Final Subsequent Environmental Impact Report
SAN FERNANDO VALLEY EAST-WEST RAIL TRANSIT PROJECT

Ventura Freeway Advanced Aerial Technology Alternative

LOS ANGELES COUNTY
TRANSPORTATION COMMISSION

July 1992

Figure 4-4
 Canoga Avenue Traffic Management Concept

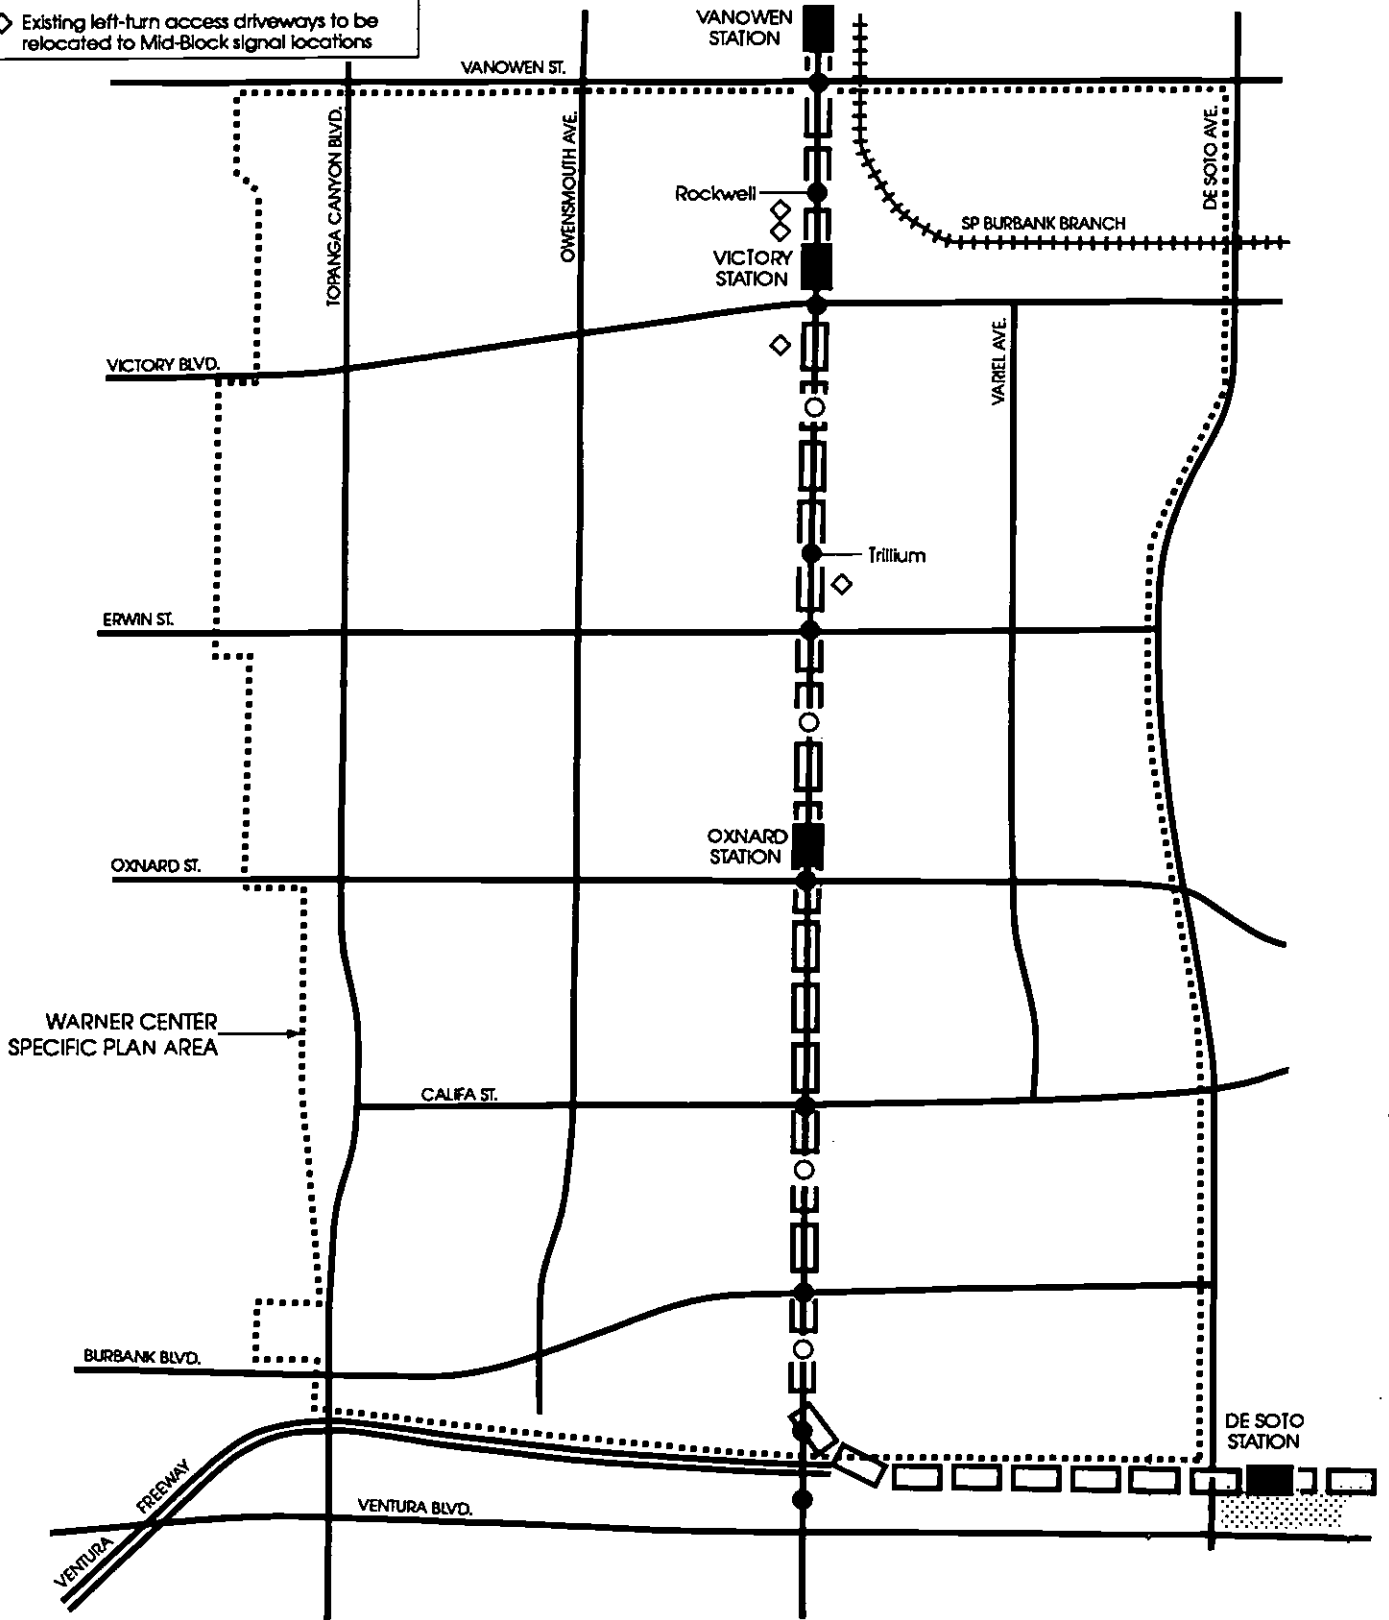
- Mitigation measures for significantly impacted intersections of Winnetka Avenue and the I-101 Freeway Eastbound Off-Ramp, and Reseda Boulevard and the I-101 Eastbound Off-Ramp were not included in the DSEIR. Mitigation measures identified for a number of the intersections were improvements that had already been implemented out in the field. Some of the existing field conditions shown on the mitigation maps shown in Figures 50 through 55 are not accurate. Since the capacity analysis is dependent on the correct lane configuration, the calculation should be re-analyzed and the revised figures, if any, should be presented in the final EIR. (LADOT)

Canoga Avenue Impact Assessment: A plan for the management of traffic along Canoga Avenue was identified and is illustrated in Figure 4-4. Figures 4-5 and 4-6 provide more detail of the concept. In general, the principal concern is that Aerial Guideway columns placed every 100-120 feet along Canoga Avenue will impair visibility of oncoming traffic and make left turns unsafe. It will therefore be necessary to provide traffic signals and left-turn pockets for all left turn movements that occur under the aerial guideway.

As shown in Figure 4-4, traffic signals are presently located along Canoga Avenue at the Ventura Freeway, Burbank Boulevard, Califa Street, Oxnard Street, Erwin Street, Victory Boulevard, Vanowen Street, and at the Trillium and Rockwell developments. In addition, numerous unsignalized left-turn movements are permitted to driveways and smaller streets located between these signalized intersections. In order to provide protected left-turn access, additional signalized intersections will be required at four mid-block locations between the Ventura Freeway and Burbank Boulevard (Litton), between Califa Street and Burbank Boulevard, between Oxnard and Erwin Streets, and between Victory Boulevard and the Trillium signal (Circuit City/Irvine Ranch Market).

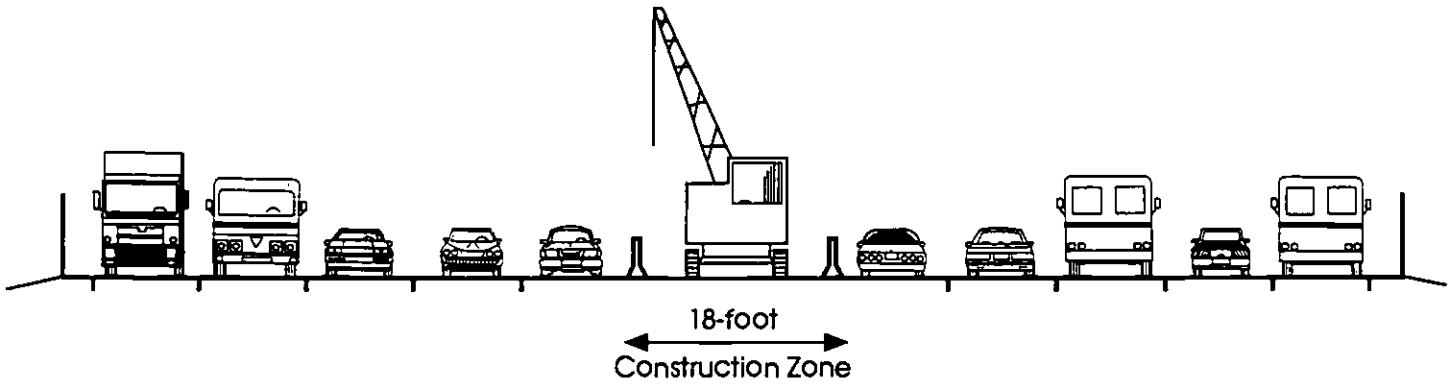
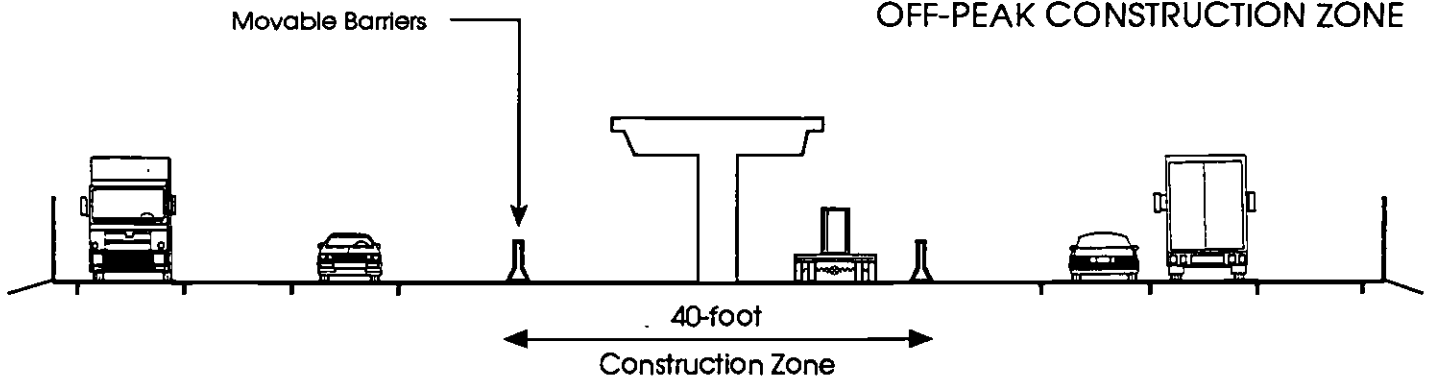
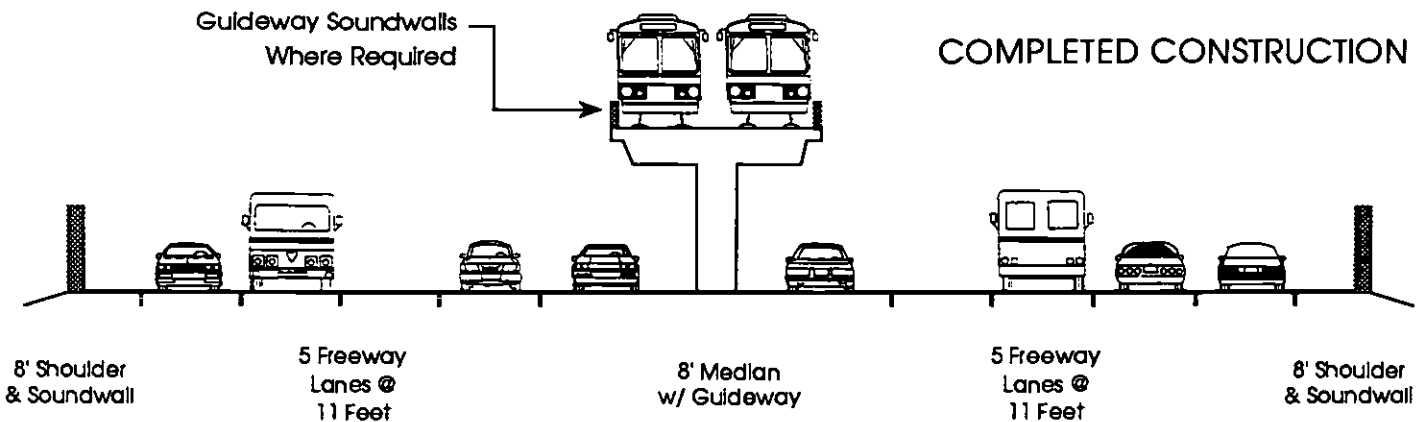
- Even someone changing a tire on the freeway causes massive traffic jams. How do they propose to handle the traffic when there's construction all the time? (Ratcliff)

The creation of a Construction Zone in the median of the Ventura Freeway would be possible by restriping traffic lanes and using the shoulder area of the freeway. A recommended alternative is illustrated in Figure 4-12. As shown in the figure, a construction zone 18-feet in width can be created by taking away 6-feet of outside shoulder in each direction and restriping the five existing 11' traffic lanes in each direction to three 11' lanes and two 10' lanes. No freeway shoulder or breakdown lane would be provided during the construction period, however tow-service vehicles would be provided which would patrol the freeway on a 24-hour basis to remove stalled vehicles. During non rush-hour periods, moveable median barriers could be shifted out to take one travel lane in each direction creating an expanded construction zone 40-feet in width.

Figure 4-13
 Aerial Guideway Column: Sizes and
 Configurations in Ventura Freeway Median

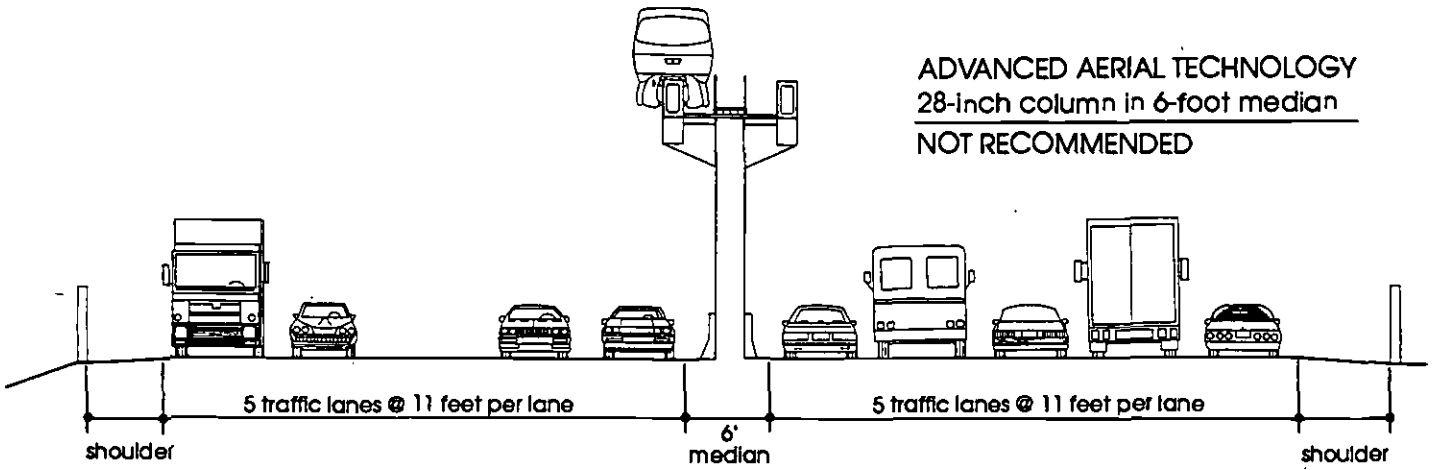
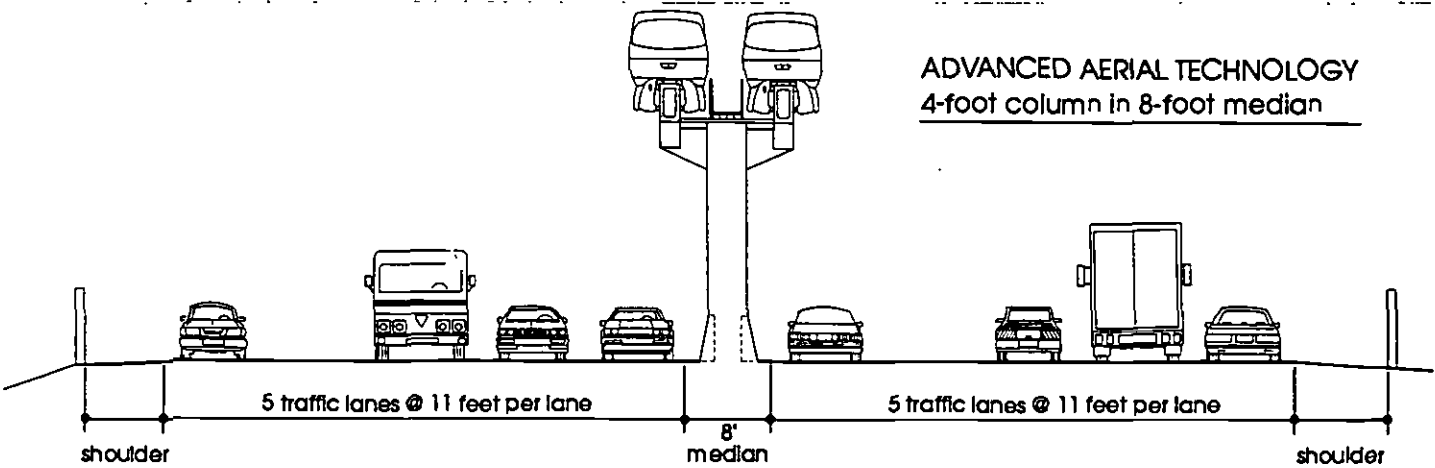
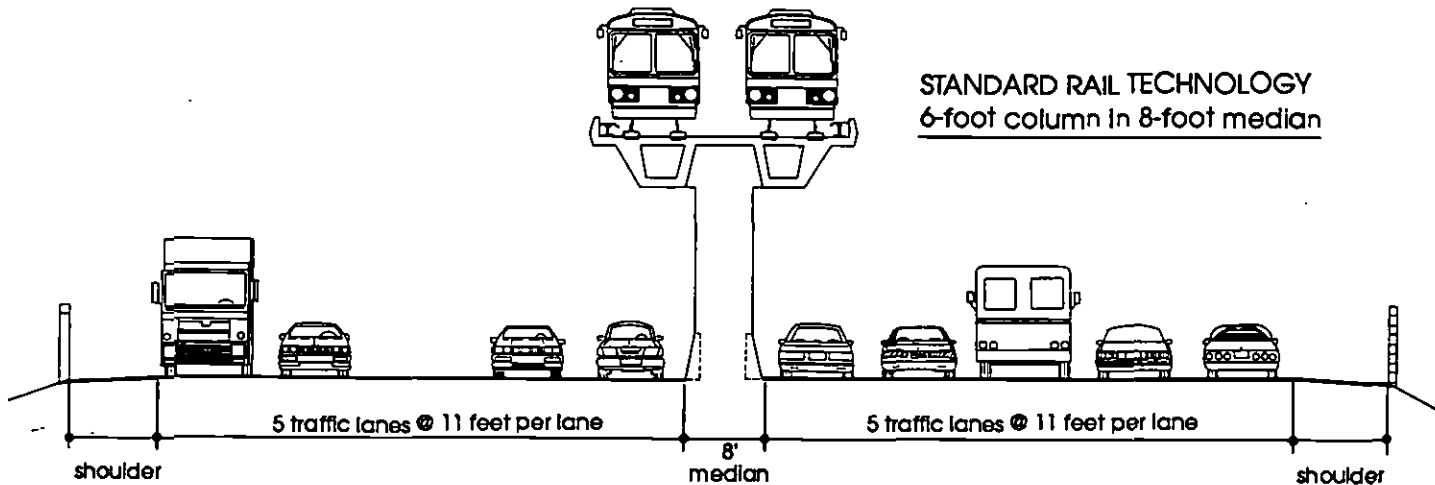
- The DSEIR proposes smaller (28" square) pilings to support the aerial guideway than have been used on similar projects. The protection barriers (described in the DSEIR, figure 22, page 55, as "new type 50D concrete barriers") are in direct contact with these pilings and are only 36" in height. The DSEIR should analyze whether these barriers are sufficient to protect the pilings if struck by a truck, bus, RV, or other large vehicle. Since the rail project proposed for the freeway has been modified to put the guideway in the middle of the freeway, current space restraints require a narrower than standard support pier. Some analysis must be done to ascertain whether such piers can be engineered to satisfy earthquake requirements and whether they can be adequately protected from traffic accidents on the freeway. (VICA-Valley Industry & Commerce Association)

Response 5.7-1 In order to address the above concerns and evaluate structural, seismic and safety concerns of the aerial guideway, Dokken Engineering, a licensed structural engineering firm with extensive experience working on the design of California freeway bridges and rail transit structures was asked to review to Draft SEIR concept design and hold review meetings with Caltrans. Meetings between LACTC and Caltrans were held on April 16 and May 6, 1992. Based on these meetings and technical analysis by Dokken Engineering³, the following conclusions were drawn:

Median Width: A thorough review of Caltrans construction drawings for the Ventura Freeway was conducted. Drawings of the original freeway construction were compared with recent widening project plans and As-Built drawings. Additionally, field inspections were conducted along the freeway to verify dimensions shown on construction drawings. Based on this review, a minimum width of eight feet was found to be available for construction of guideway columns in the median area instead of the previously assumed six foot minimum dimension. Even though typical cross-section drawings show some cases where a six foot median had been planned, no instance was found where a reduced median width of six feet had been implemented.

Nominal Column & Footing Dimensions: In order to comply with such seismic building codes and for purposes of conceptual level design and environmental review, Dokken Engineering developed recommendations for nominal column & footing dimensions appropriate to the conceptual level of project design. These sizes are illustrated in Figure 4-13.
